PROTEST- PETITION
This form may also be used for objections

PETITION FOR TIME EXTENSION, CHANGE, TEMPORARY URGENT CHANGE

Protest of the California Department of Water Resources' and U.S. Department of the Interior, Bureau of Reclamation's Petition for Change in Points of Diversion and Rediversion of Certain Permits within the Sacramento/San Joaquin Delta Estuary

RE: Solano County Comments on the Draft Bay Delta Conservation Plan (BDCP) / California WaterFix (CA WaterFix) Partially Recirculated Draft Environmental Impact Report and Supplemental Draft Environmental Impact Statement (RDEIR/SDEIS)

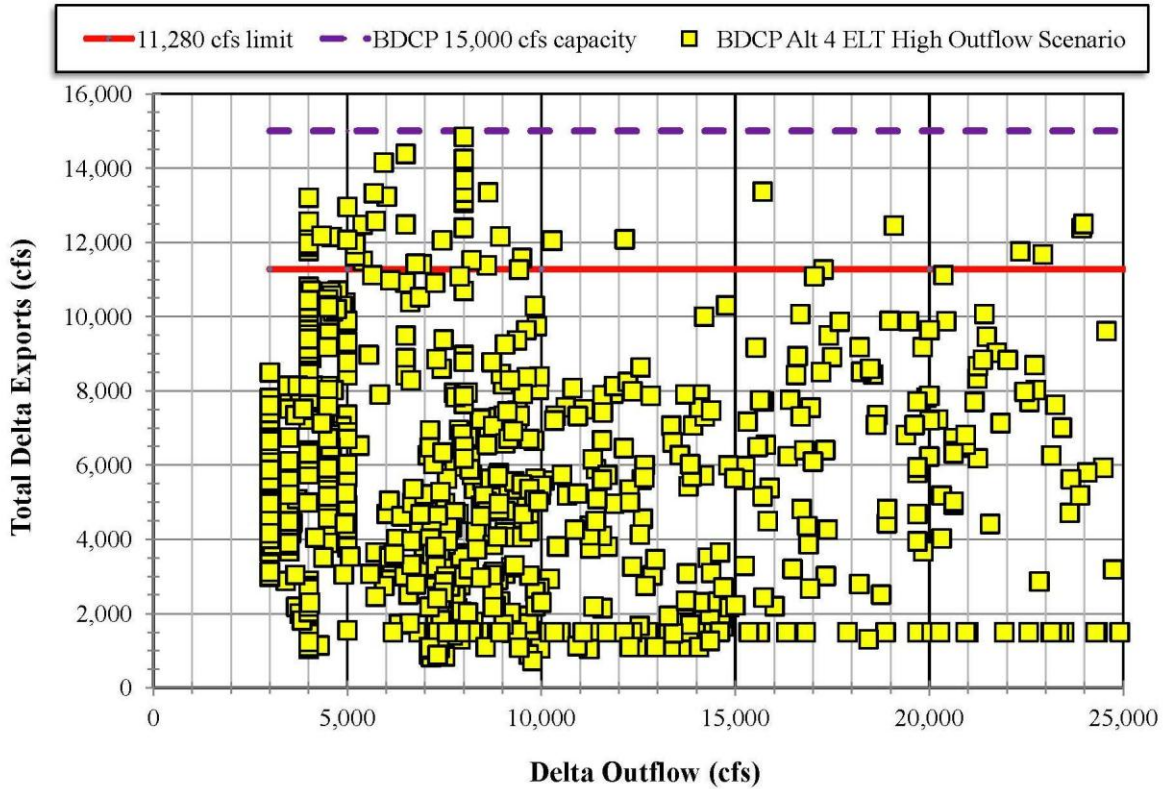
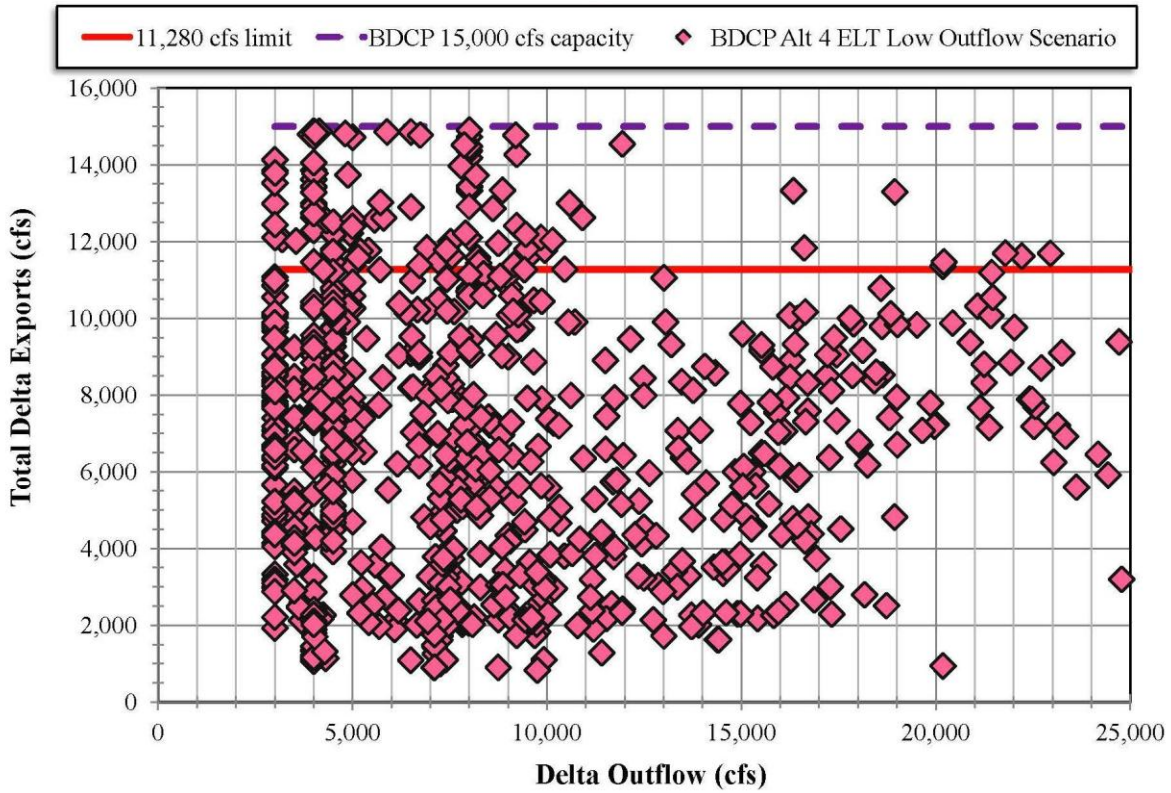
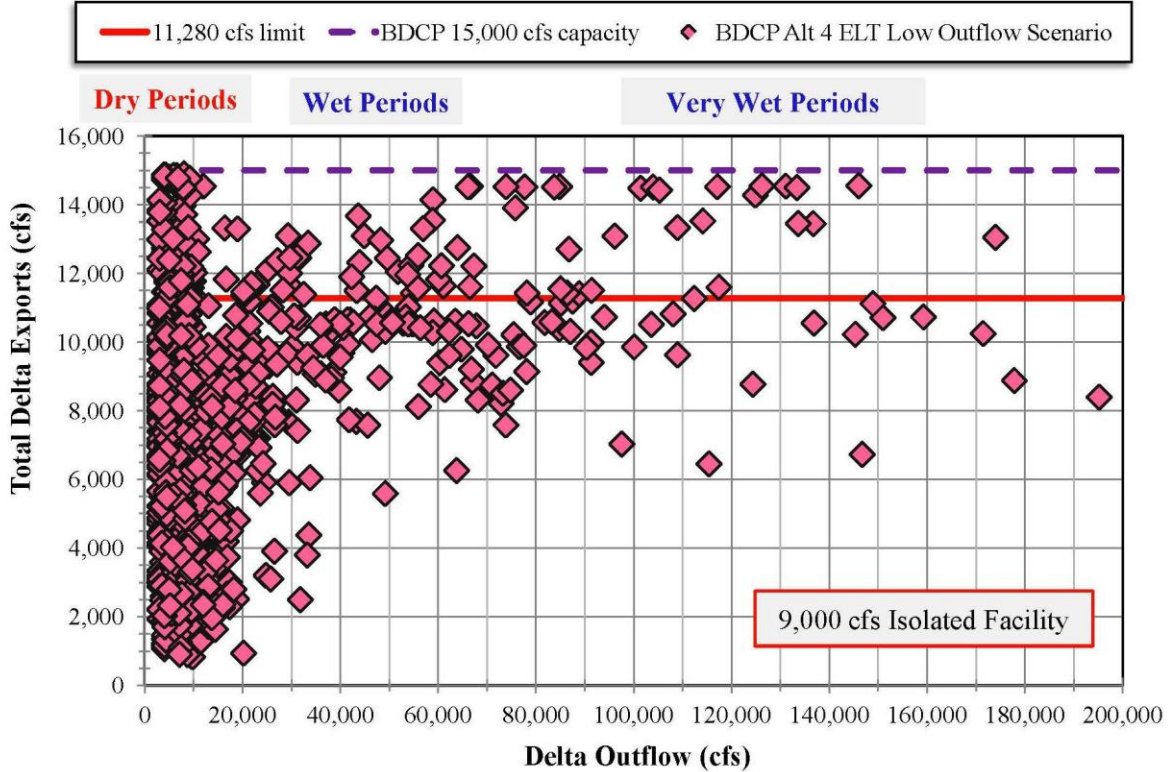
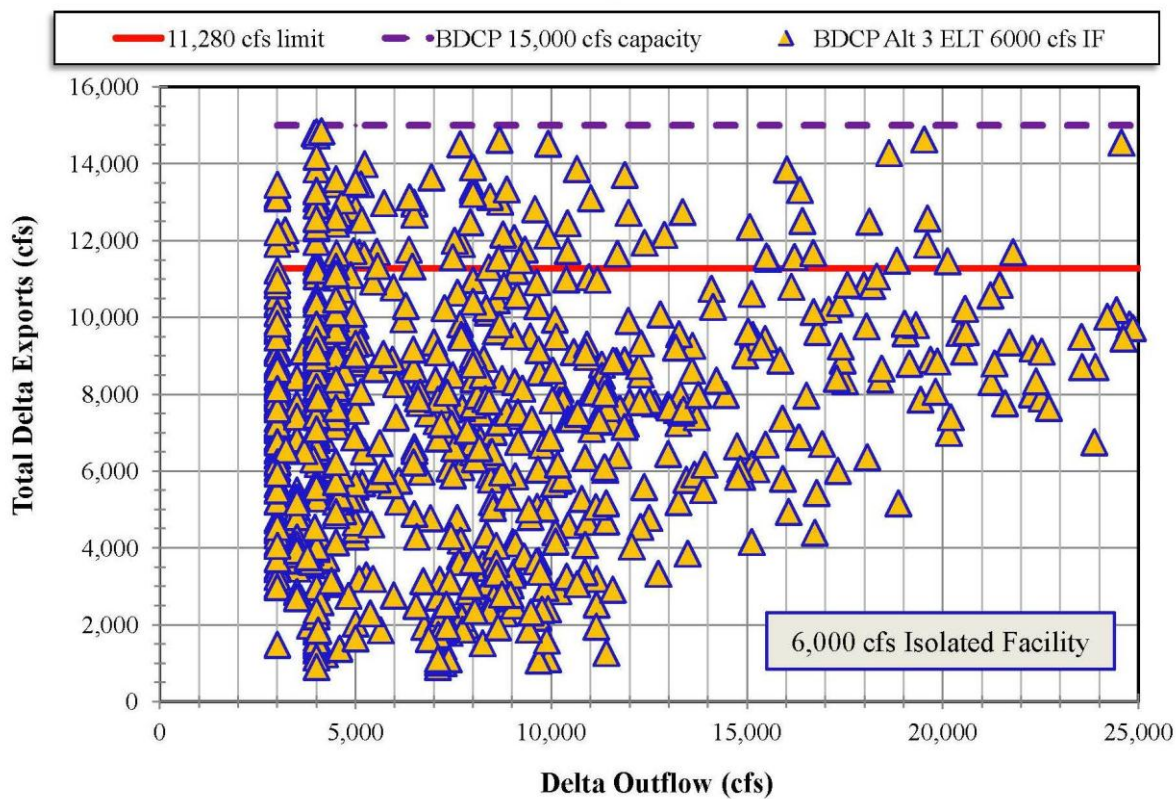
The total export graph for existing conditions is the same as the plot of south Delta exports (Figure A-2) because there are currently no north Delta intakes or isolated facilities.

Figure A-9: Total exports as a function of Delta Outflow for BDCP Early Long Term Alternative 3 which has only 6,000 cfs of north Delta intake tunnel capacity. There are more months with exports in excess of 11,300 cfs during wetter periods (high outflow) than for Alternative 4 (9,000 cfs isolated facility). The reasons for this should be discussed and disclosed in the EIR/EIS.

To ensure that the BDCP operations actually reduce exports during periods of low Delta outflow, it will be necessary for the SWRCB and fishery agencies to set limits on exports based on Delta outflow. The minimum Delta outflows in D-1641 could be increased to 4,000 cfs to provide more protection for fish species. If the current lowest value of 3,000 cfs were retained, then the total exports could be limited to 3,000 cfs. Similarly, if the Delta outflow were 7,100 cfs, the combined SWP and CVP exports could not exceed, say, 10,000 cfs. No more than 13,000 cfs could be exported unless the Delta outflow remained at least 11,400 cfs.

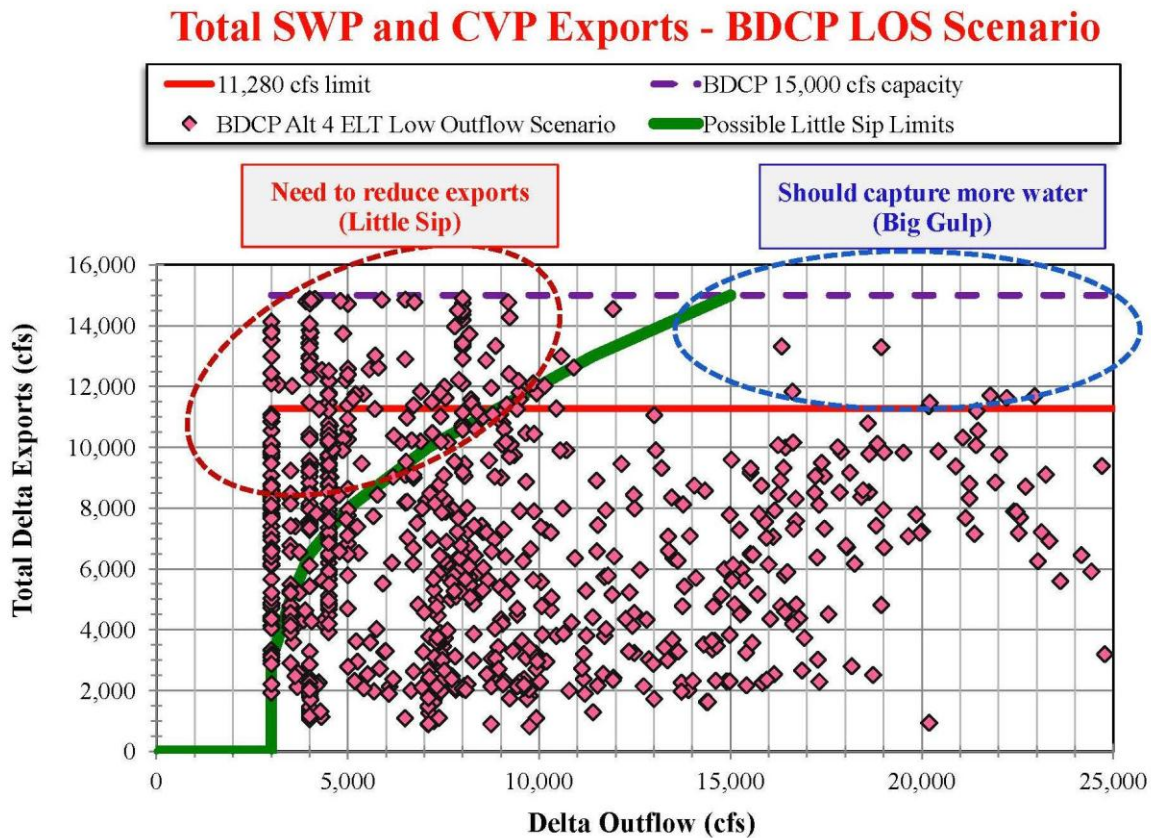
These hypothetical “Little Sip” limits on total exports are shown in Figure A-10. The “Little Sip” export limits are compared with the same Low Outflow Scenario data plotted in Figure A-7. The limit on total exports increases with increasing Delta outflow, and would allow for export increases in wetter periods to capture water when it is surplus.

The BDCP proposed project is deficient because it fails to reduce exports during drier months. This is in part due to the assumption that key operation limits on export operations will be eliminated (e.g., the Army Corps limits on Clifton Court inflow and NMFS Biological Opinion limits on the San Joaquin inflow to south Delta exports limit).

These limits on total exports are hypothetical, but are consistent with the principle of reducing exports in drier months, and reducing reliance on the Delta for water supply.

Figure B-1: Variation in daily EC data for the Barker Slough area from October 1976 to October 1983 from the BDCP water quality modeling. Four simulations are shown; No Action at late long term, proposed project Low Outflow Scenario at ELT and LLT and proposed project High Outflow Scenario at LLT.

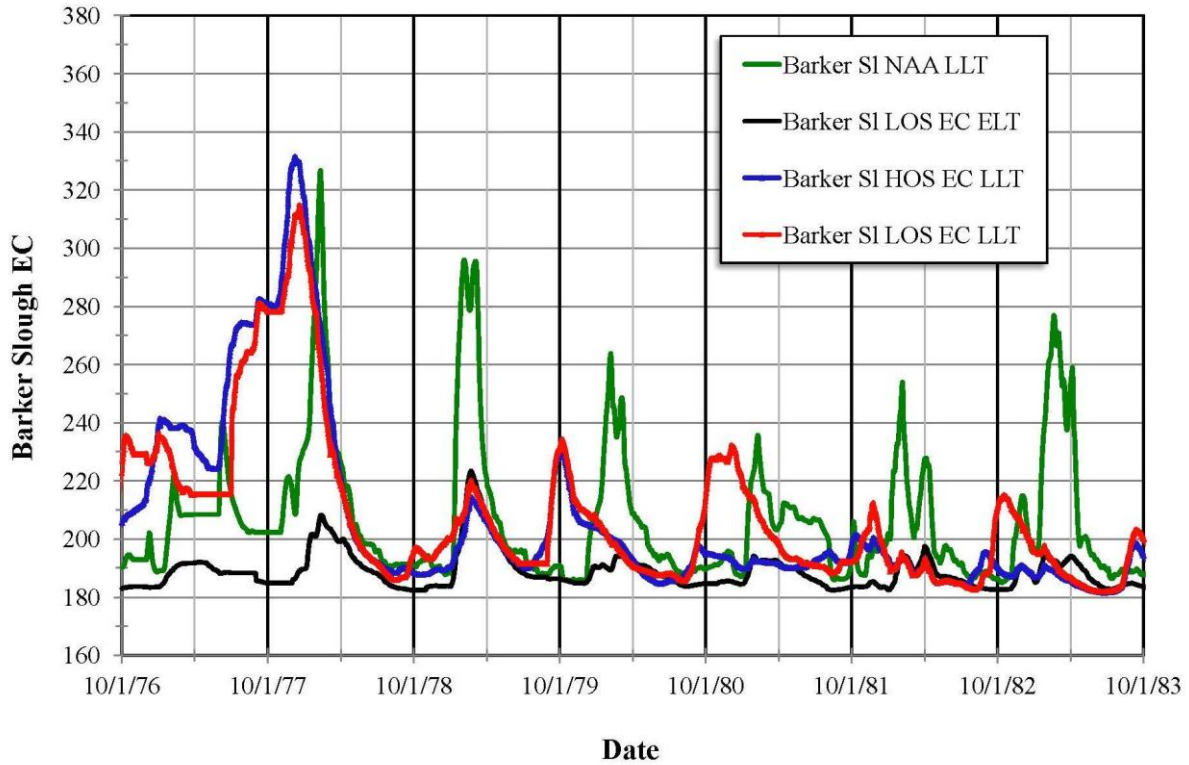
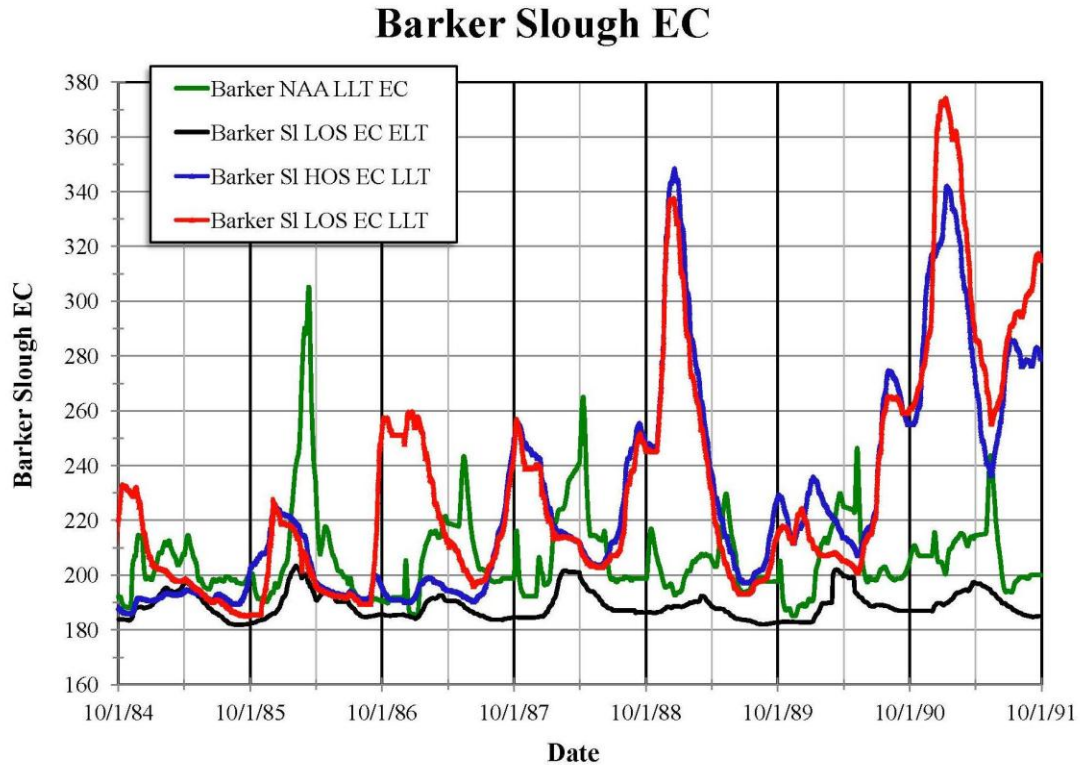
Figure B-1 presents daily EC data for the Barker Slough area for the period October 1976 through October 1983. The data are from four simulations performed for the BDCP using DWR's DSM2 water quality model. The four simulations are:

The data in Figure B-1 suggest that the BDCP proposed project will not only significantly increase the salinity of irrigation water for farmers in and near Solano County, but will change the time of the periods of high salinity. The peaks of salinity for the no action alternative at late long term (LLT) occur primarily in February and March and are due to local agricultural drainage (according to the DSM2 fingerprint analysis). The peak salinities for the proposed project at LLT occur earlier in some years (in the fall) and are due to increased seawater intrusion.

The data in Figure B-1 also suggest that habitat restoration in the north Delta after early long term (ELT) and the resulting changes in local flow patterns, combined with additional sea level rise, will cause significant adverse impacts to irrigation water quality in this region. The salinities for the Low Outflow scenario at ELT are much smaller and primarily due to local agricultural drainage.

Figure B-2 shows the variations in EC for the same scenarios for the period October 1984 through October 1991.

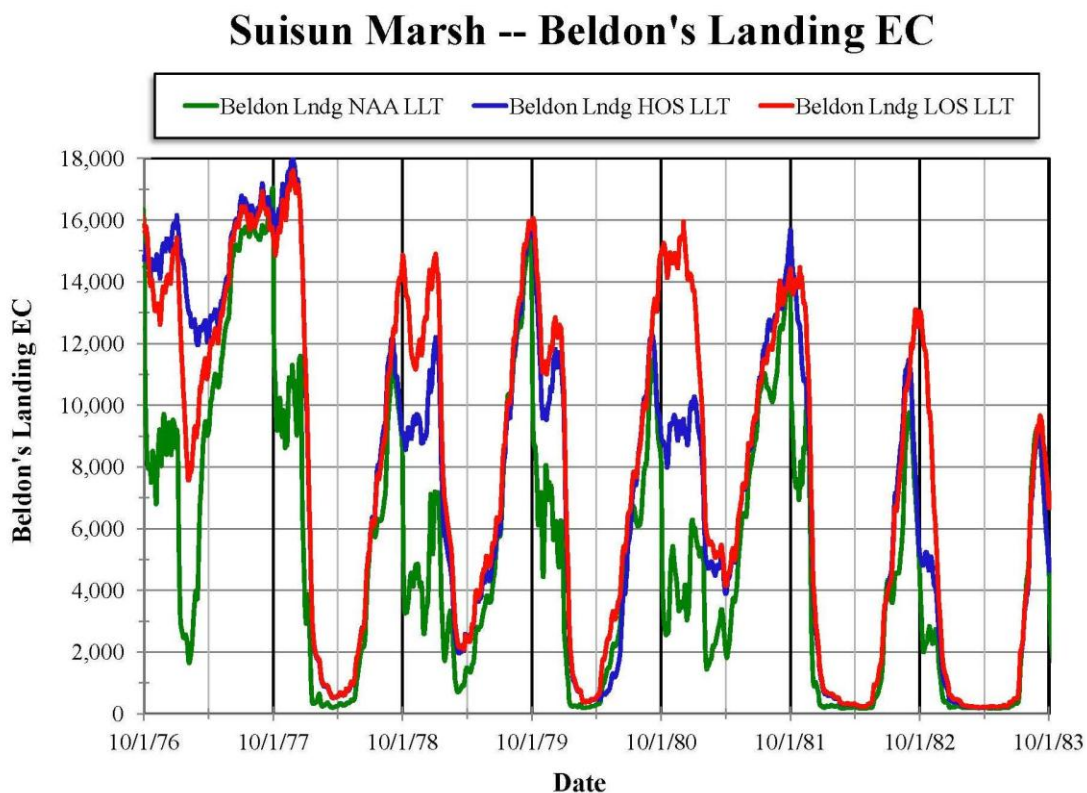
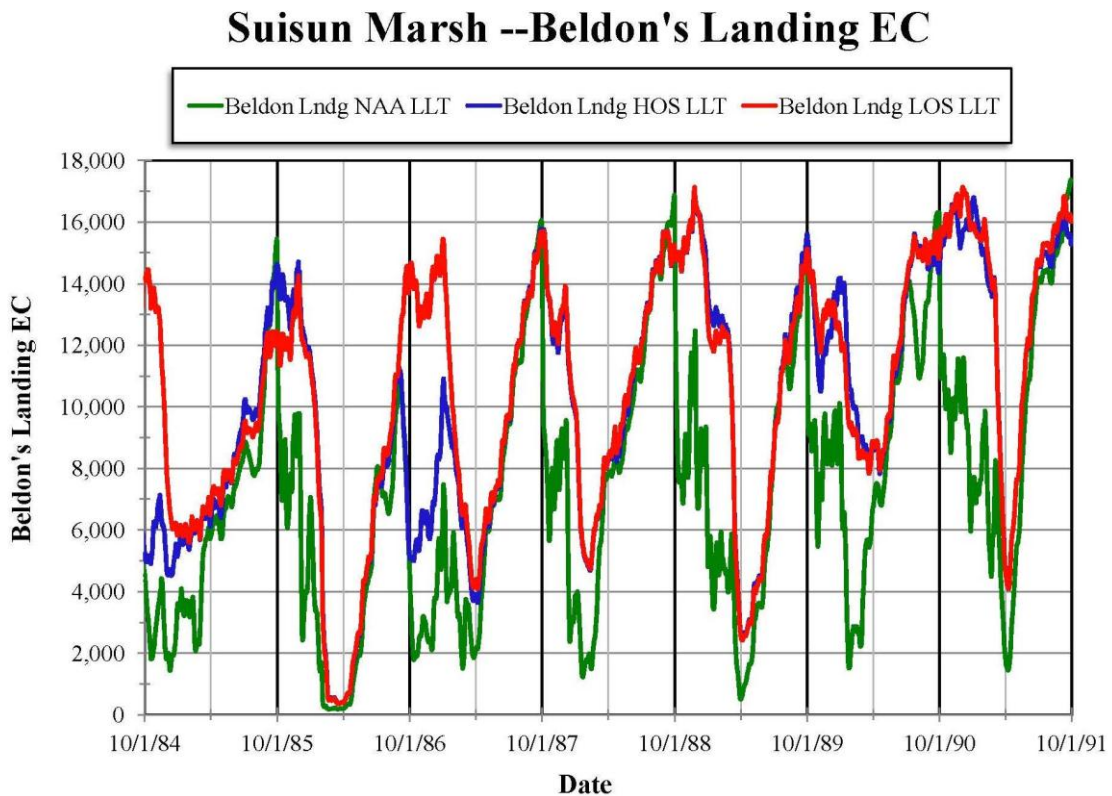
The DEIR/EIS is inadequate because it only assesses Suisun Marsh EC qualitatively, using average EC for the entire period modeled (1976–1991) – see Chapter 8 of the DEIR/EIS at page 8-157. The 82-year averages suggest that the BDCP proposed project would substantially increase salinities at Montezuma Slough at Beldon’s Landing (i.e., over a doubling of concentration in December through February) (DEIR/EIS, Appendix 8G, Figure CI-8). This will seriously impair the ability of Suisun Marsh landowners to manage water quality and will adversely impact fish and wildlife beneficial uses. However, the 82-year averages do not disclose sufficient detail about the timing and magnitude of the salinity changes for individual months of different water year types.

Figure B-3 shows the BDCP simulations of the variation in daily EC in Suisun Marsh at Beldon’s Landing from October 1976 through October 1983. There are significant adverse impacts to salinity for the proposed project for both the Low Outflow and High Outflow scenarios. The largest increases in salinity occur primarily in the fall. The impacts are greatest for the Low Outflow scenario which assumes there will not be any Fall X2 requirements.

Figure B-4 shows the corresponding Beldon's Landing salinity data (EC) for the period October 1984 through October 1991.

These increased EC levels in Suisun Marsh are substantial and will have adverse impacts on marsh beneficial uses, and must be mitigated.
